Access Compliance Report

Public Rights-of-Way

(Curb Ramps)

Intersection ID: 4977	Main Street: CARMATHEN_RD	Cross Street: CASTLEMAINE_DR	Location: SE
ADA ID: 26A53B9C5AE5	Ramp Type: Perp	Initial Pass/Fail: Fail	Overall Compliance: No
Severity Score: 33.75			
Codes/Mitigation Info/Possible Solution		Field Measurements/Component Compliance

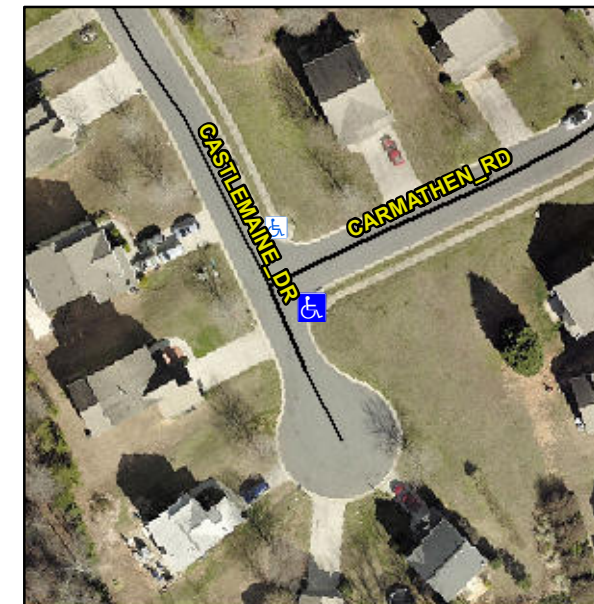
Not Found, R304.5.1, R304.5.3

Compliance	Description	Data	Compliance	Description	Data
N/A	Ramp Length (in)	47.0	Yes	Ramp Slope (%)	5.7
No	Ramp Width (in)	42.0	No	Ramp XSlope (%)	11.2
N/A	Flare Type LT	N/A	N/A	Flare Type RT	N/A
N/A	Flare Slope LT (%)	N/A	N/A	Flare Slope RT (%)	N/A
N/A	Flare Traversable LT?	N/A	N/A	Flare Traversable RT?	N/A
N/A	Landing Length (in)	N/A	N/A	DWS Provided?	N/A
N/A	Landing Width (in)	N/A	N/A	DWS Contrast?	N/A
N/A	Landing Slope (%)	N/A	N/A	DWS Length (in)	N/A
N/A	Landing X Slope (%)	N/A	N/A	DWS Full Width?	N/A
N/A	Landing Curb? (Y/N)	N/A	N/A	DWS Offset (in)	N/A
N/A	Shared Landing?	N/A			
N/A	Gutter Ponding?	N/A	N/A	Gutter Slope (%)	N/A
N/A	Gutter Lip Ht (in)	N/A	N/A	Gutter X Slope (%)	N/A
N/A	Painted X Walk1?	No	N/A	Painted X Walk2?	N/A
	X Walk 1 Direction	To N		X Walk 2 Direction	N/A
N/A	X Walk 1 Width (in)	N/A	N/A	X Walk 2 Width (in)	N/A
	X Walk 1 Slope (%)	4.5		X Walk 2 Slope (%)	N/A
	X Walk 1 X Slope (%)	8.0		X Walk 2 X Slope (%)	N/A

Remove & Replace Entire Ramp.
